**FINDINGS OF THE THIRD TECHNICAL COMMITTEE FOR REVIEW OF
DIVERSION FLOW MEASUREMENTS AND ACCOUNTING PROCEDURES**

LAKE MICHIGAN DIVERSION

AUGUST 5, 1994

Prepared for:
U.S. Army Corps of Engineers
Chicago District
Chicago, Illinois

FIGURE 3.8

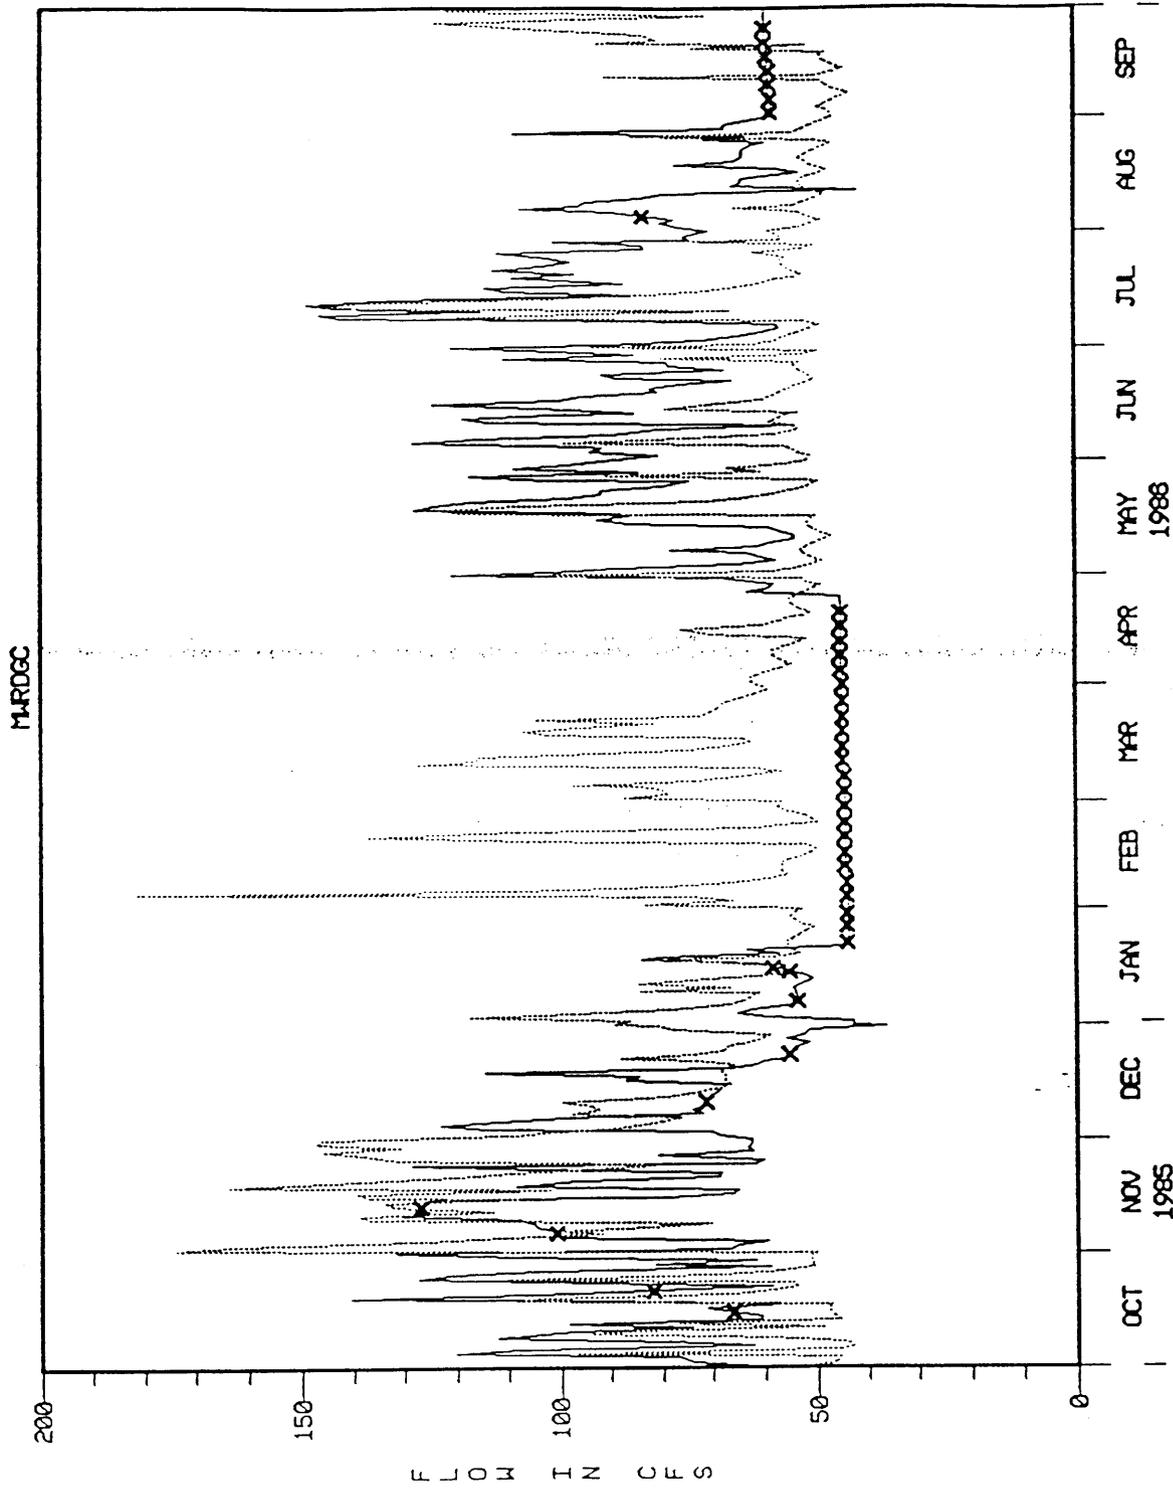
The Burke infiltration and inflow study raises more questions than answers. The Burke recommendation of assigning 100% of the subsurface runoff to infiltration clearly violates physical reality. This leads to a dilemma: Either the subsurface flow from HSPF is too small or the conceptual model of sewer infiltration using HSPF and SCALP is wrong.

The subsurface component can be increased by either increasing the inflow through infiltration from the surface or by reducing the evapotranspiration and percolation to deep groundwater. It is unlikely that one can adjust these parameters sufficiently to compensate for the 15% shortfall. Is there any other source of inflow into the lower zone? Infiltration into the lower zone can only come from pervious areas. Can impervious areas be reassigned to the pervious category, thereby increasing the inflow into the subsurface areas? Are rooftops considered impervious area? Roofs drain through gutters onto yards which is a pervious area. Do impervious areas contribute to the lower zone through cracks in the pavement and through exfiltration from sewers under surcharge? The subsurface component of HSPF was designed to simulate the flow of water from soil storage into stream channels - thus creating base flow. This concept is similar but different from the infiltration into sewers. The infiltration into sewers is caused by a head of water forcing water through joints into the pipe. Is a different conceptual model which would simulate the pressure component needed?

FIGURE 4.3

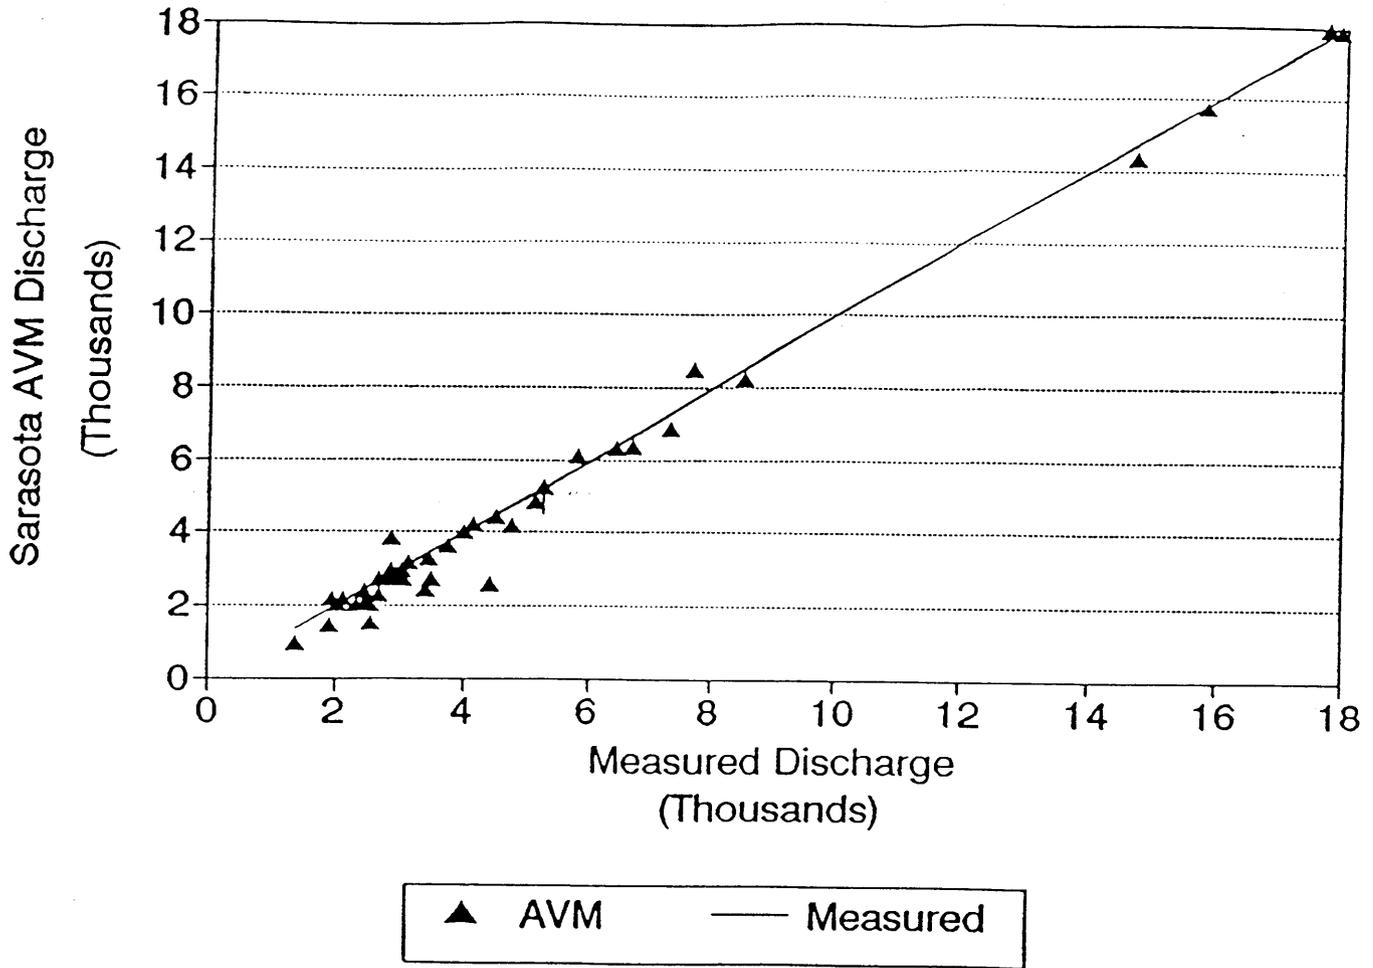
Measurements 1 through 41 were made to verify the Sarasota AVM calibration. The AVM discharge data as well as the measured discharges are listed in Table 4.1. A plot of these data, Figure 4.3, shows that during the period when the AVM was working properly, the calibration remain reasonable constant throughout the period, and the AVM discharge records compared fairly well with the measured discharges.

FIGURE 4.4

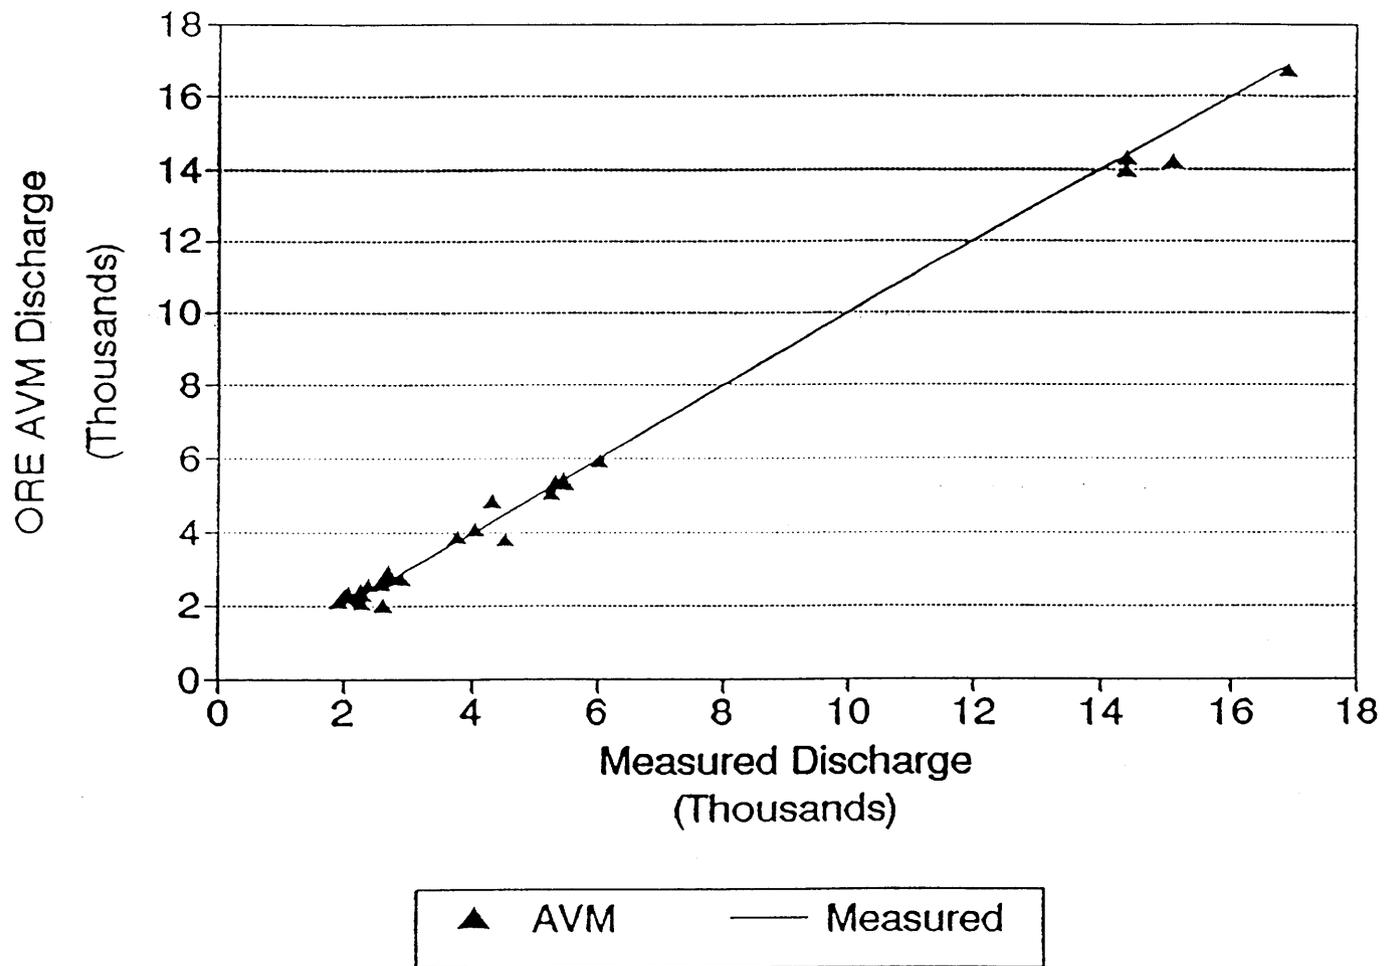
Measurements 42 to 73 were made to verify the calibration of the ORE AVM. Pertinent data are listed in Table 4.1, and for the purpose of comparison are plotted in Figure 4.4. The data in Table 4.1, as well as the plot in Figure 4.4, show that during periods of normal operation the ORE AVM discharge records compare reasonably well with the measured discharges.

Based on the above observations it is evident that the equations yield acceptable results. However, evaluating the equations according to guidelines (Laenen, 1992), the equations are theoretically incomplete, because the velocities are not adjusted as a function of stage. The guidelines suggest that including K factor, as defined by equations 1 or 2, in the discharge equations, would provide a tool for developing ratings where stage is a significant rating factor.

Figure 1a Variation of Depth correction x with Time - March 84 to Aug 1990

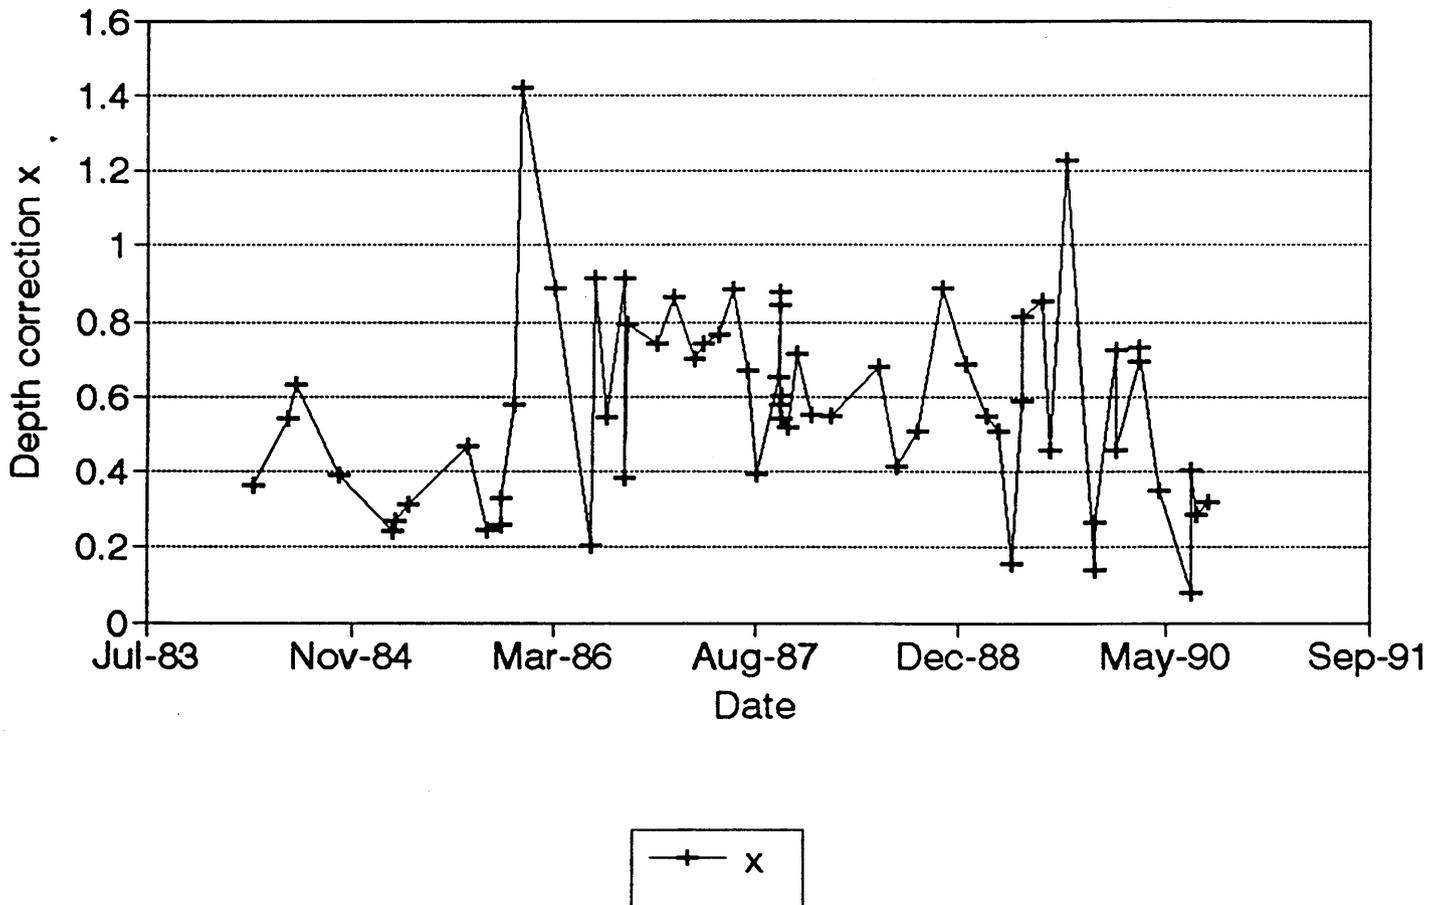
Figure 1a shows a plot of the X values vs. time for the period of record. Figure 1a is a graphic representation of the continuously changing mean bottom of the canal. It shows that during the period of record from March 1984 to August 1990 the mean bottom elevation ranged from about 0.2 to 1.4 feet. The mean for the period of record is about 0.60 feet below the zero of the gage. The results of this analysis indicate that it would be prudent to measure the cross section periodically to determine if a correction or shift to the rating is needed to account for changes in the mean bottom elevation.

With this as a background, an alternative explanation for the apparent changes in the depth-correction factor with time is presented. Figure 10 of the draft report illustrates these changes well. Measurements 1-62 were all made from the upstream side of the Romeoville Road bridge. This approximately coincides with the location of the downstream cross-section. Measurement 67 was made from the Lemont Road bridge approximately 4 miles upstream. Measurements 63-66 and 68 were made using a boat, halfway between the downstream transducer assembly and the midpoint between the upstream and downstream transducer assemblies. Measurements 69-72 were all made halfway between the upstream and downstream transducer assemblies. As the measuring point moved further upstream, the mean depth increased.
